ADDENDUM NO. 2 TO 14-0053-4

**FOR: JENNIFER ROSS SOCCER COMPLEX DROP-OFF AND PARKING**

## **Jennifer Ross Parking and Drop-Off Addendum #2**

LANDSCAPE PLAN

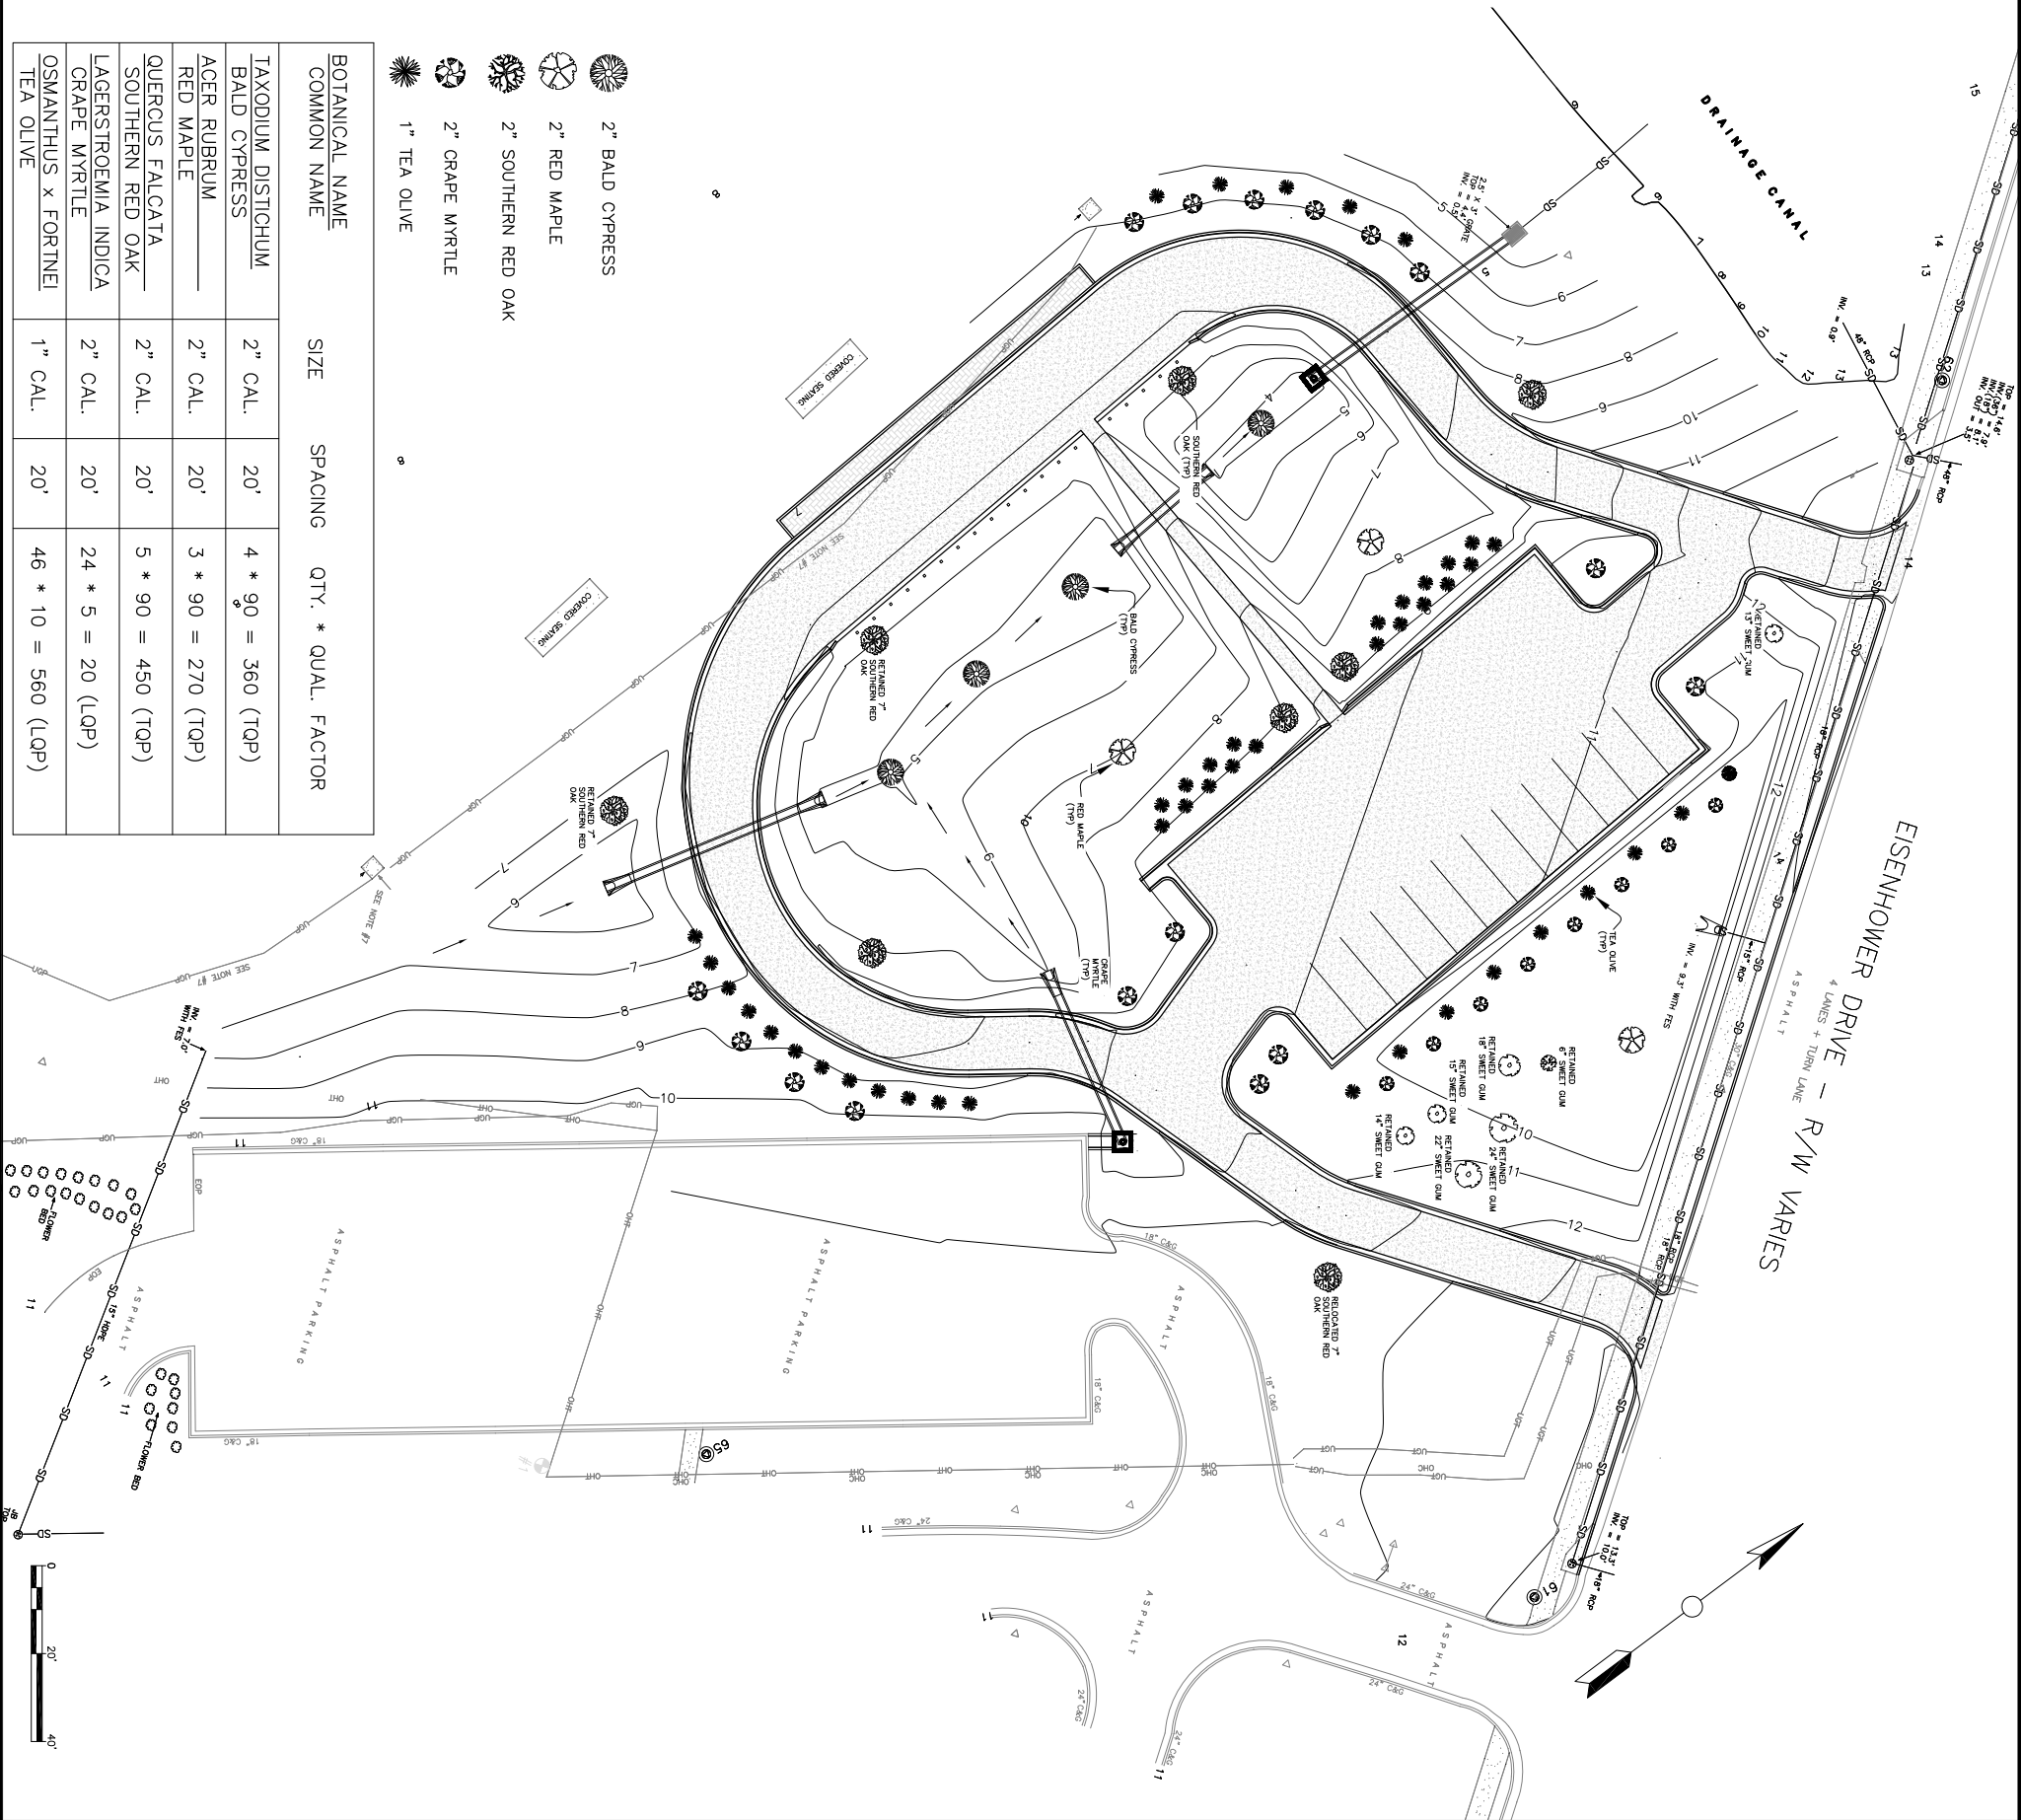
1. Responses to ADDITIONAL questions received. (2 sheets)
2. Replace current Bid Sheet (from Addendum 1) with the attached REVISED Bid Sheet. (1 sheet)
3. Replace current Plan Sheets with the attached REVISED Plan Sheets ( 4 sheets):
  - ES&PC Intermediate Phase (Sheet # 9)
  - Landscape Plan (Sheet #12)
  - Construction Details (Sheet # 13)
  - Construction Details (Sheet # 14)
